GOVERNMENT OF THE DISTRICT OF COLUMBIA
DEPARTMENT OF TRANSPORTATION

MEMORANDUM

SUBJECT: **BZA Case No. 19053** – Ridge Lofts – 446-452 Ridge St. NW

Figure 3 PM Weekday Peak Parking Occupancy (Source: Grove/Slade)

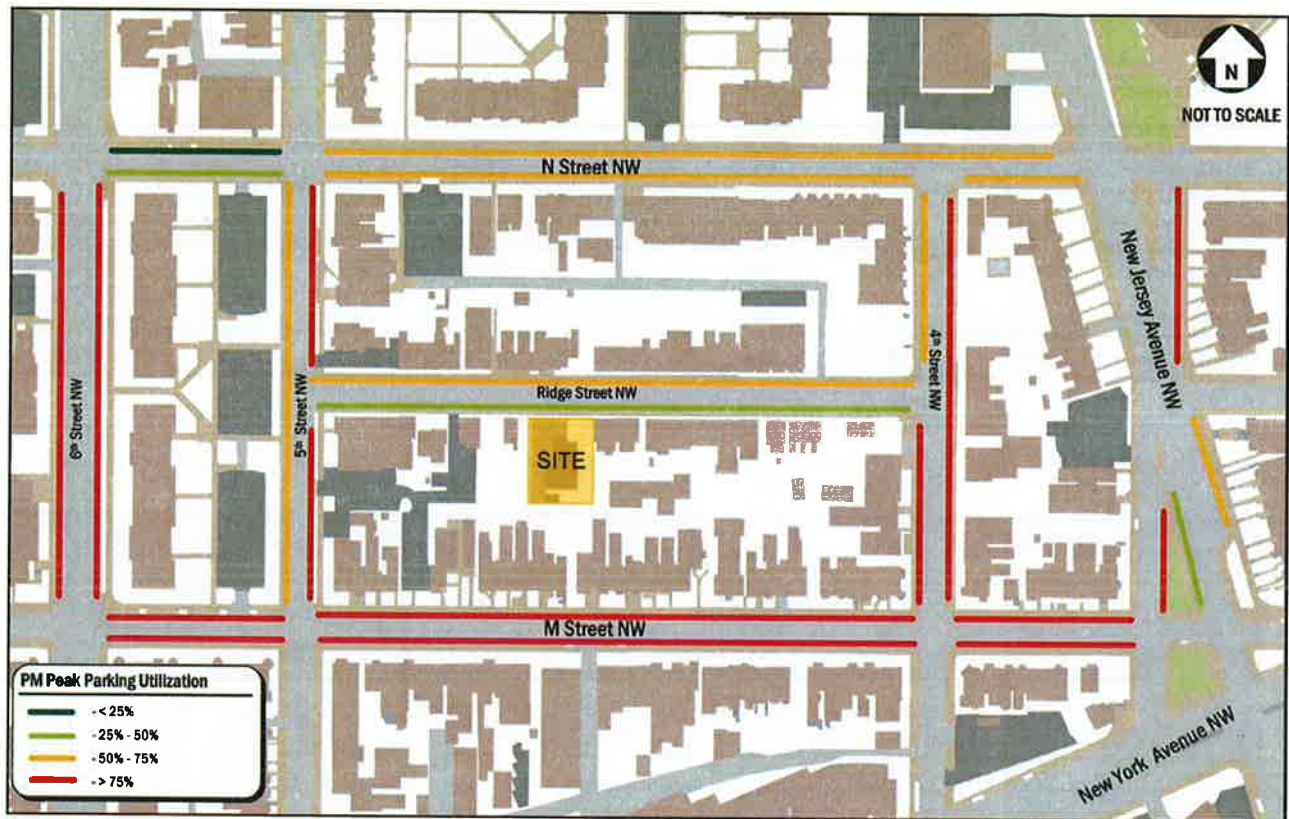
Zoning requires the provision of four parking spaces for the proposed eight dwelling units located on four lots. The Applicant requests full parking relief. While this variance request does not meet DDOT's threshold for a vehicle parking occupancy study, a study was conducted by the Applicant. Parking occupancy data was collected on Thursday, May 28, 2015 from 7:00 am to 9:00 pm. This analysis shows unused nearby on-street parking that would meet the proposed project's parking demand, with 107 spaces available during peak weekday demand in the study area (9:00 pm to 10:00 pm), and 23 spaces available on the 400 block of Ridge Street where the proposed development is planned (see Figures 1, 2, and 3). DDOT finds that the available parking spaces will accommodate the expected peak hour site generated vehicular trips and parking demand.
